**Summary of Additional Comments Received after Publishing Planning Commission Hearing Notice on June 6, 2018**

## Exhibit E - Summary of Additional Comments Received after Publishing Planning Commission Hearing Notice on June 6, 2018

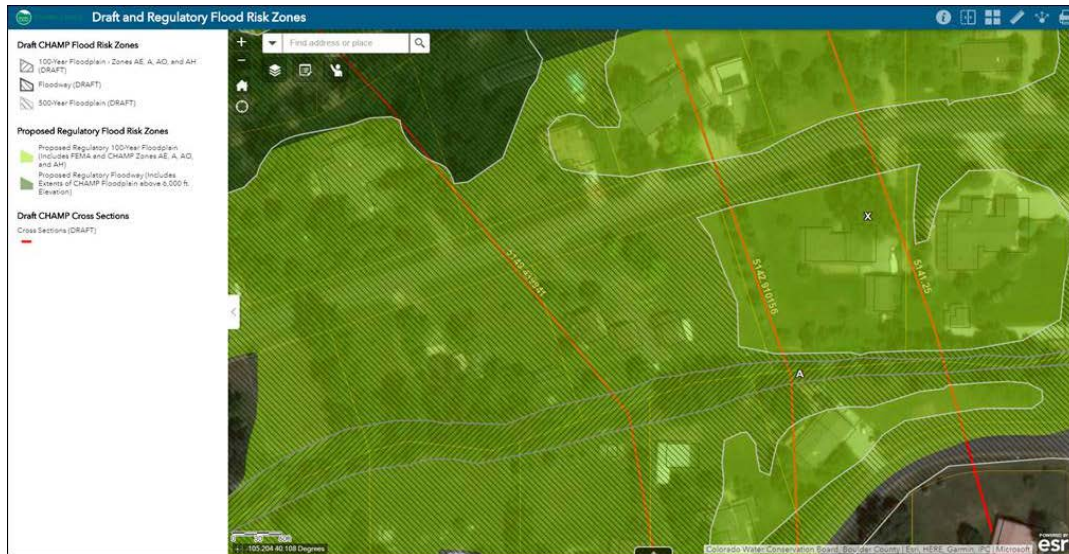
Did this CHAMP map bust get sorted out? I'd like to bring it to the attention of the planners in their 6/20 Planning Commission Public Hearing.

The draft CHAMP indicates the BFE just west of my house as 5149.44'. This same BFE (noted as XS 1114 in the plans) is stated as 5,149.89'. Which is correct? The draft CHAMP indicates a LOWER BFE than what is shown on my plans. Is the draft CHAMP incorrect?

Let's start with the Base Flood Elevation (BFE) value that raised some confusion when you looked at your plans versus the online webmap. The BFE in your house plans submitted for SPR was calculated for the upstream corner of your house, and as a result is not the same BFE measurement as that taken at the upstream cross section to the west of your house. The different values represent different locations.

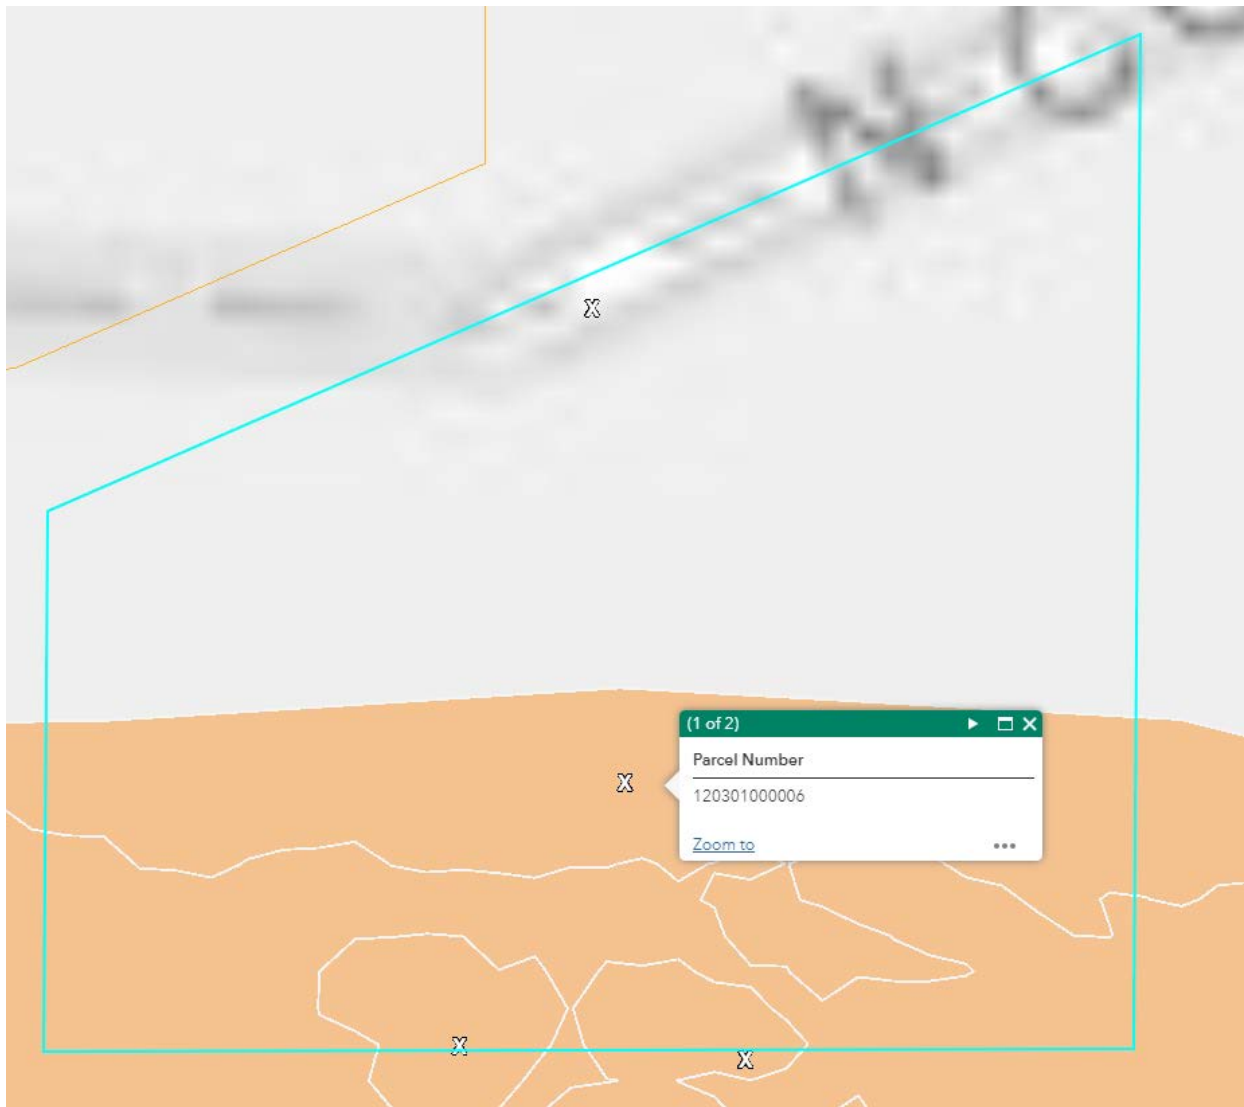
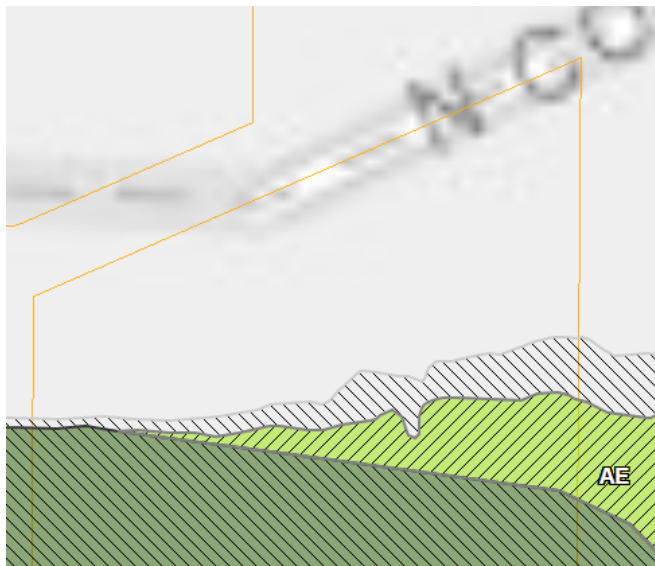
My name is Derena Beard (Tveten) and I have a parcel of land affected by the floodplain re-mapping. By the current map, roughly half of my parcel is covered by the 500 year flood plain (see below).

By the new proposed mapping, my parcel is now roughly half covered by the 100 year flood plain and a third by the floodway.

Could you please help to explain what this means with regards to the potential to build on this parcel?

The proposed changes show that the majority of your property that was regulated as the 500-yr flood zone (0.2% annual chance flood event) will now be regulated as the 100-yr (1% annual chance flood event) and Floodway as a result of updated data and technology used to develop the floodplain mapping. These higher-risk flood zones come with higher regulatory restrictions for development in an effort to protect health & safety in flood risk zones. We would want you to come in to speak with our team or the Land Use Department with specific questions, but in general:

- The 100-year floodplain requires flood protection measures to be taken when building in these areas, as well as elevating structures 2 feet above the Base Flood Elevation. Additional detail can be found in Article 4-400 of the Land Use Code – see [this document](#).
- The Floodway is most restrictive for development – no new structures can be built in the Floodway due to the significant potential for downstream debris and other factors. Please also refer to the Land Use Code for details on this regulation.

The northern portions of your property have no floodplain limitations on them at this time. Please let us know if you have further questions.
